CITY OF CARMEL-BY-THE-SEA PLANNING COMMISSION

REGULAR MEETING Wednesday, June 14, 2023

CITY OF CARMEL-BY-THE-SEA PLANNING COMMISSION Staff Report

SECOND PLANNING REVIEW SUBMISSION (2023)
CARPENTER STREET ELEVATION SHOWING SHADOWS CAST ON NORTH NEIGHBOR
SCALE: 1/4"=1'

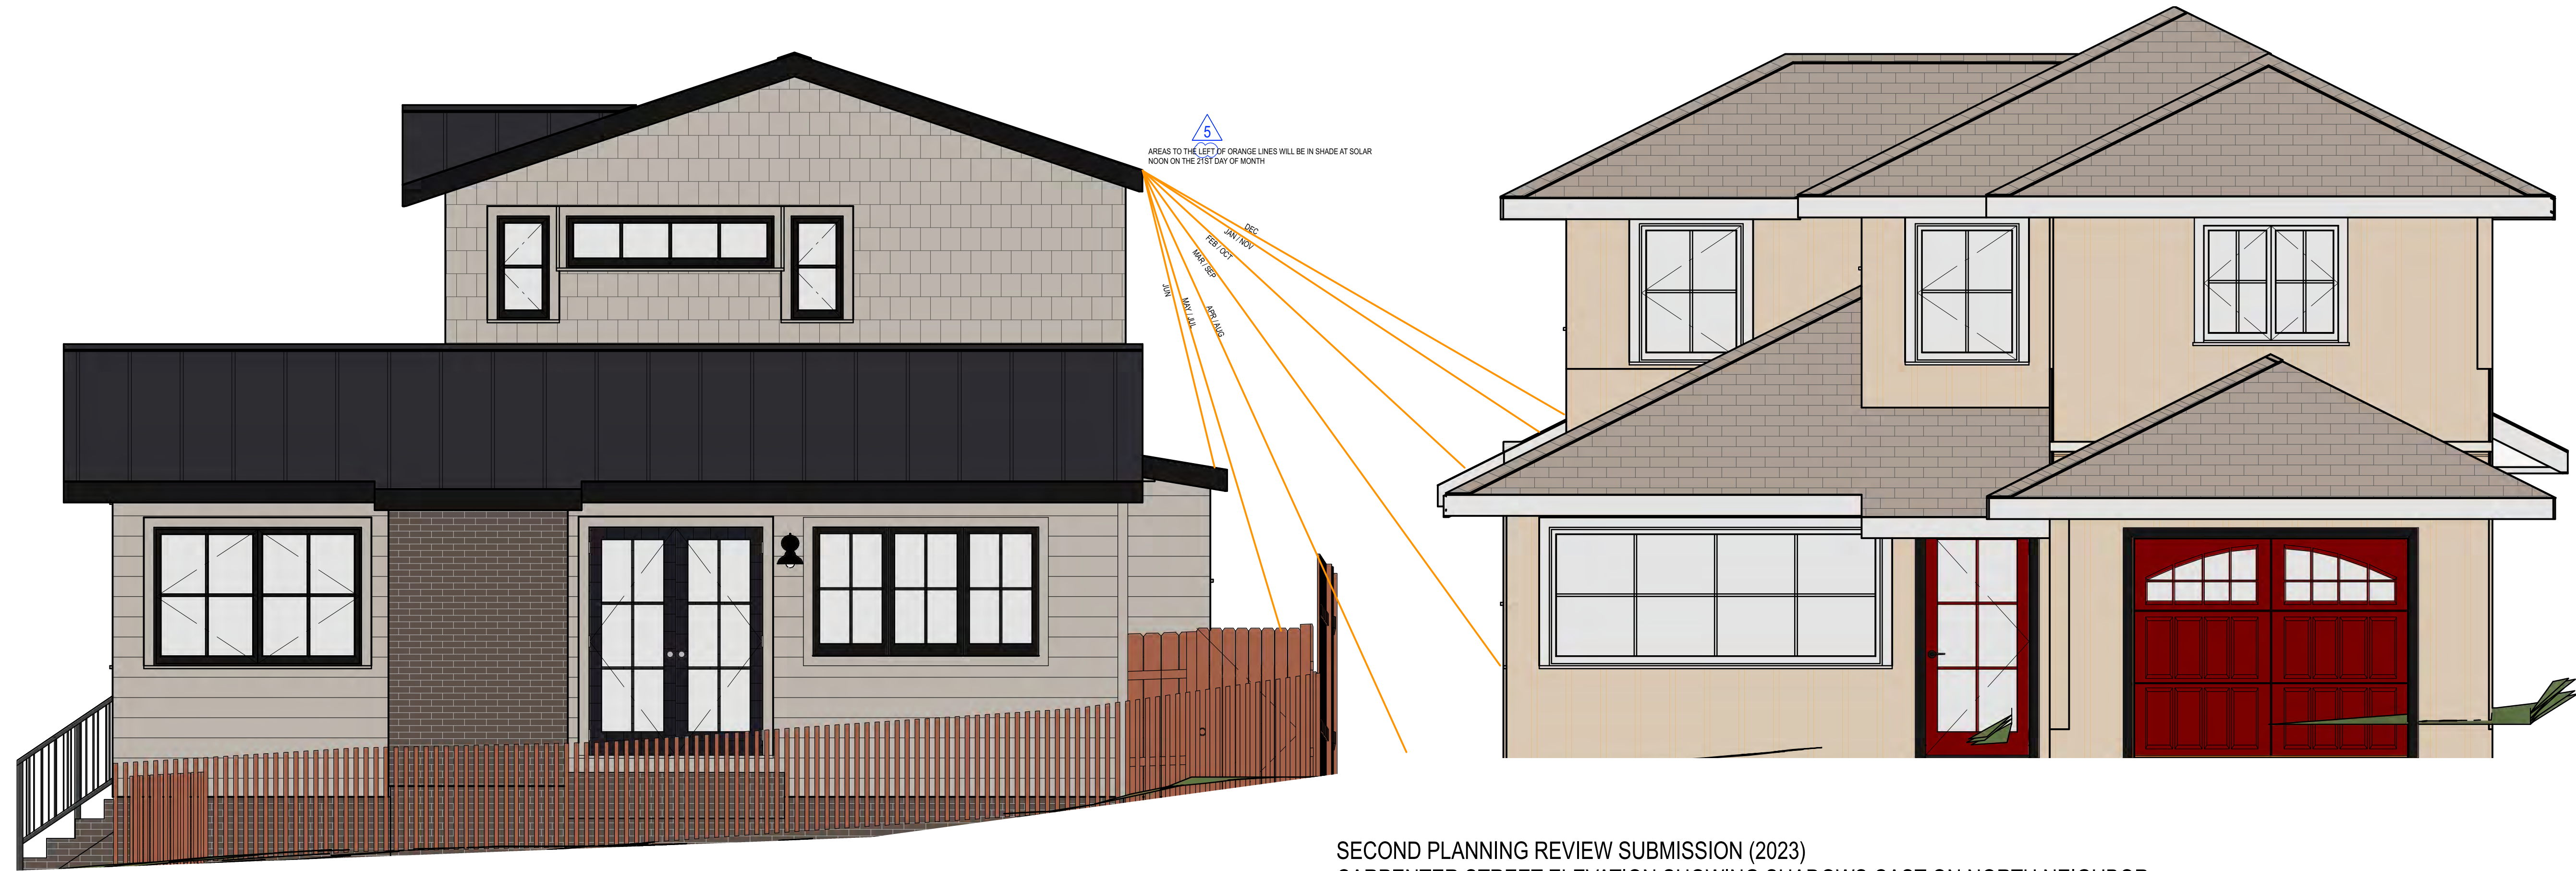
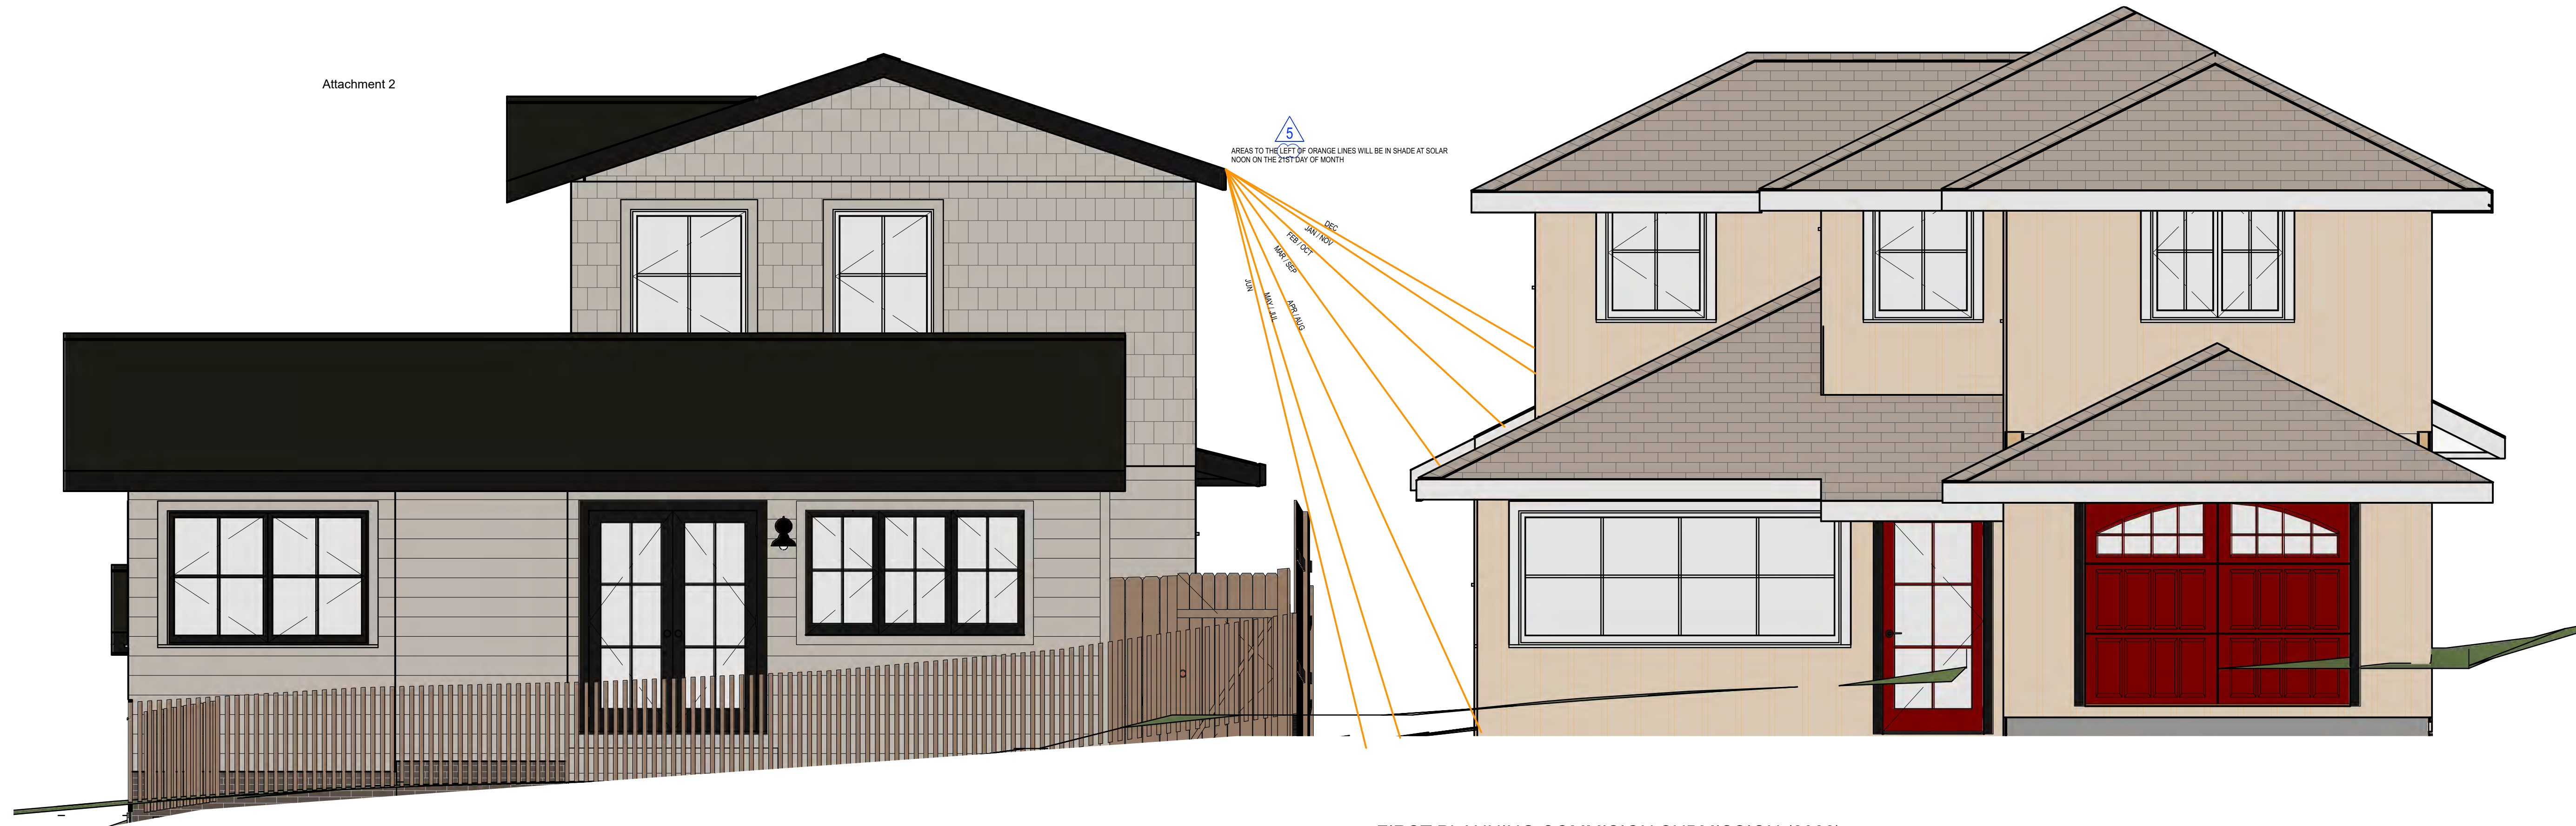
The applicant has updated the solar study to reflect the shifting of the two-story building mass to the south and west, the associated increase in the side yard setback, and the reduced eave depth. These changes increase the northern neighbor's exposure to sunlight at the first-floor windows compared to the original concept design (Attachment 3, Sheet V-1.2).

PROPOSED EXTERIOR LIGHTING PLAN

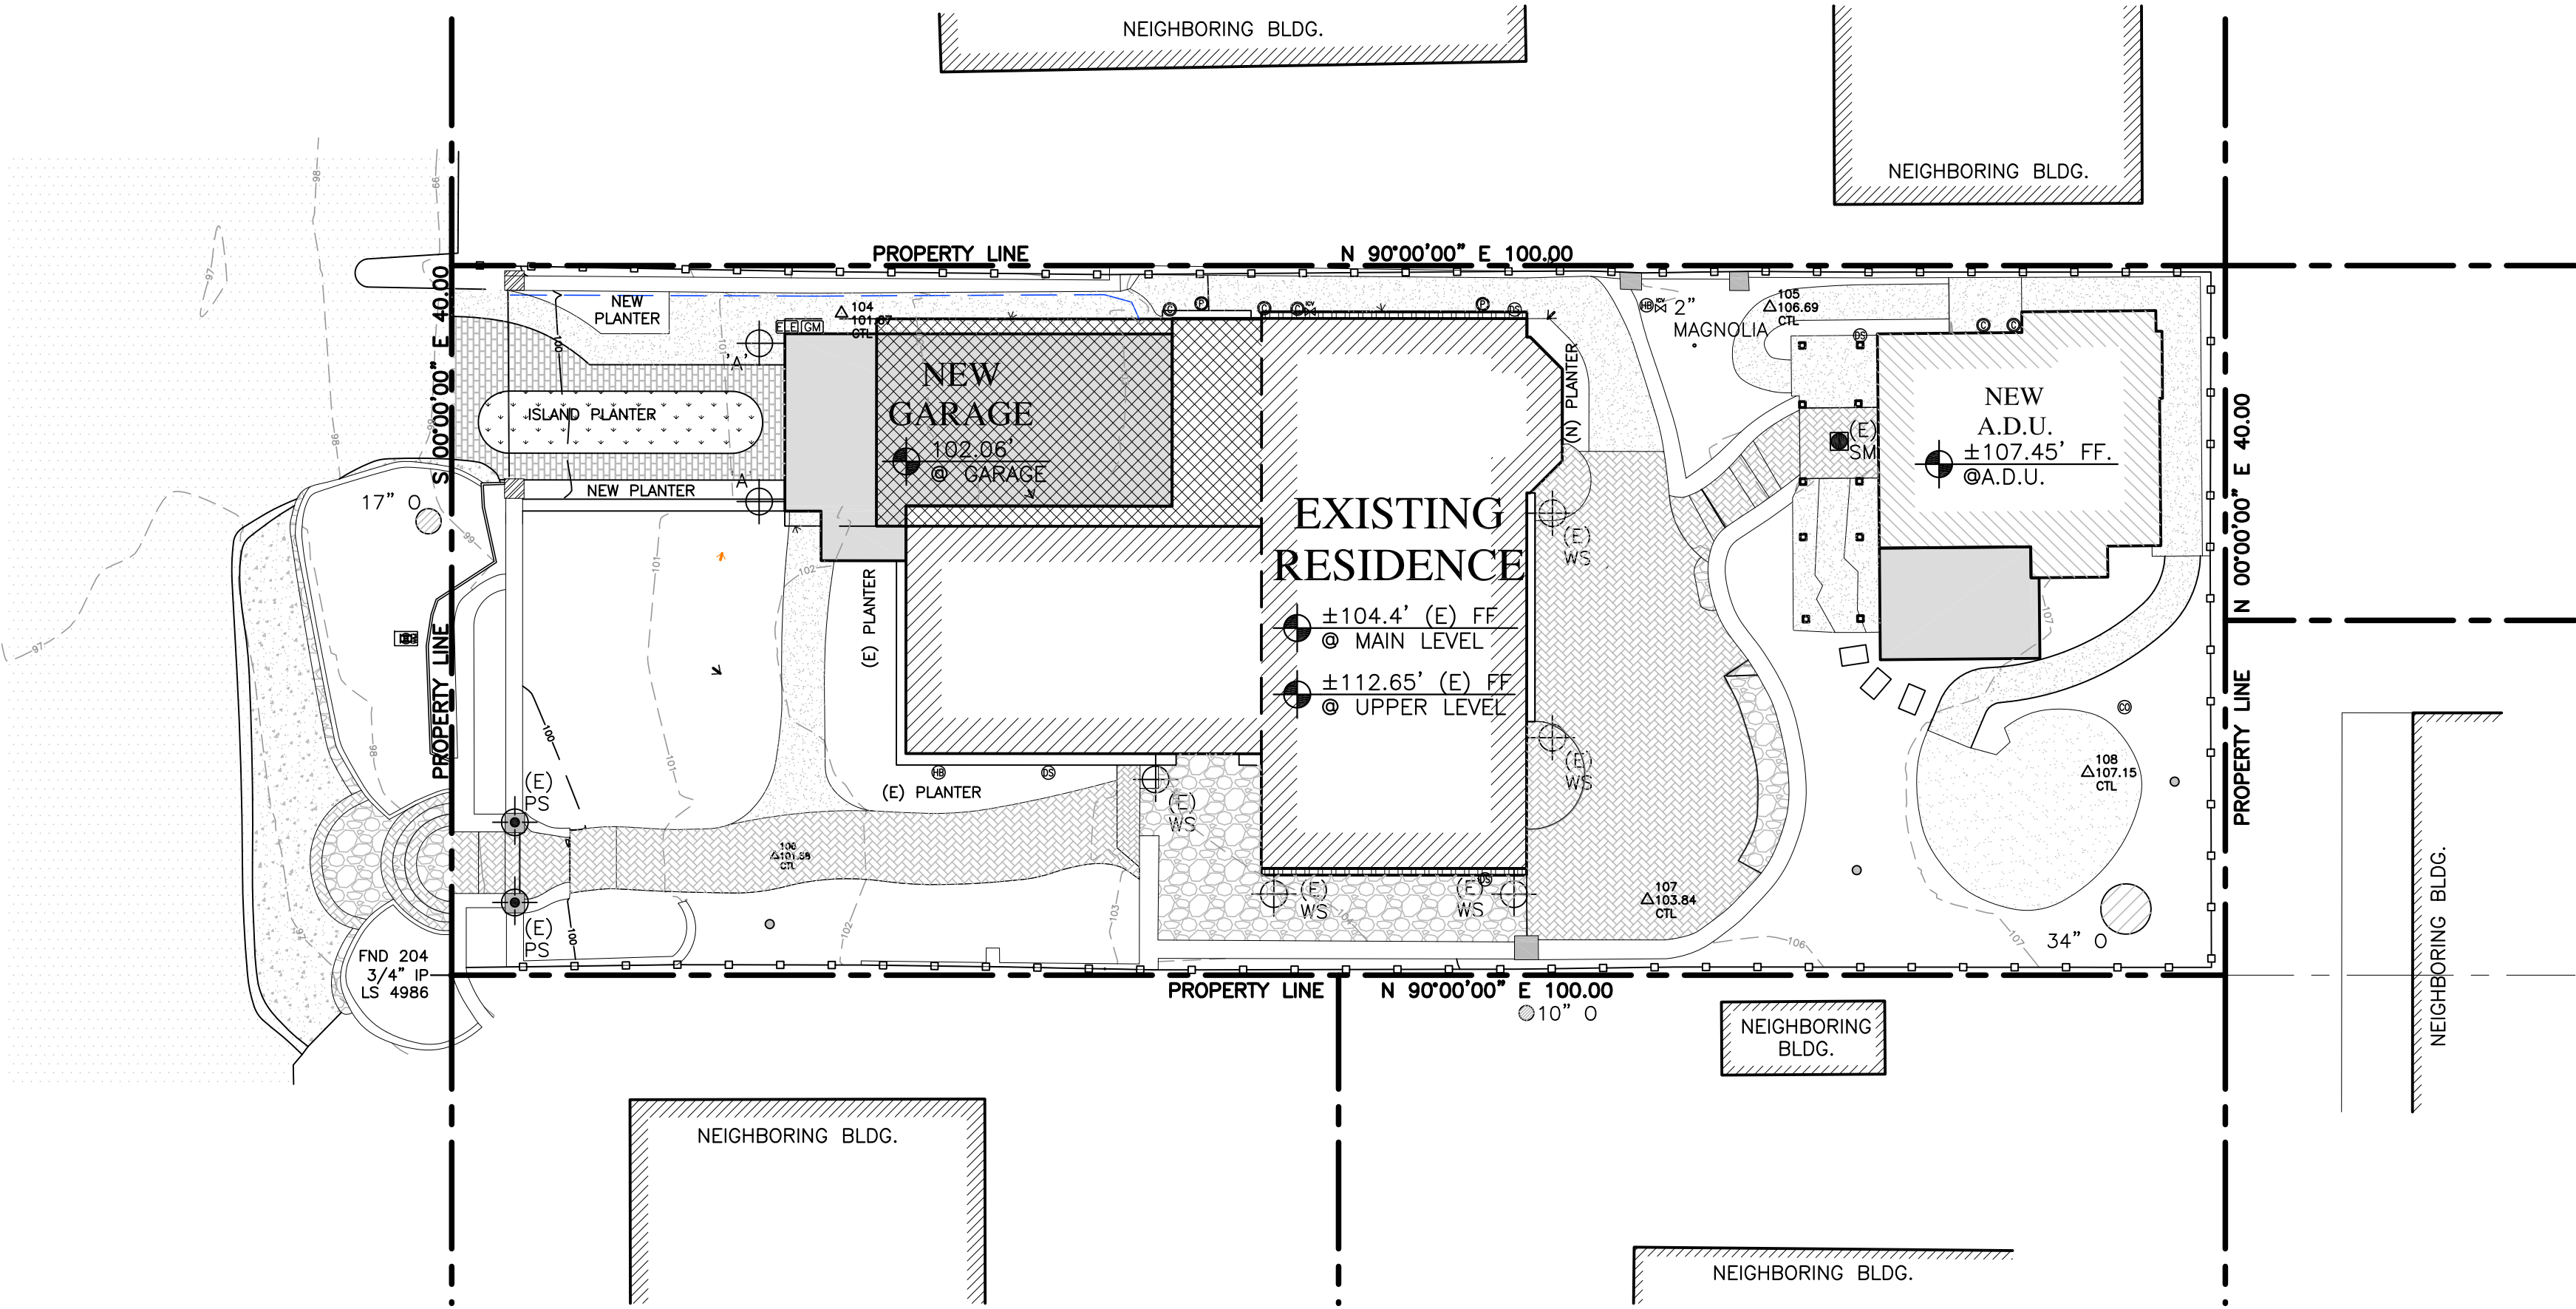
Staff Response: The applicant proposes an outdoor wall sconce with a bronze finish by WAC Lighting. The sconce shields the light element and directs light downward. The fixture delivers 314 lumens and is rated dark sky compliant. The applicant has incorporated the standard lighting requirements on Sheet F-1.1 of the plan set. On Sheet A-2.1, two wall-mounted fixtures are proposed, one at the front entry and one at the double doors leading to the front patio. The project meets the objectives for exterior lighting.
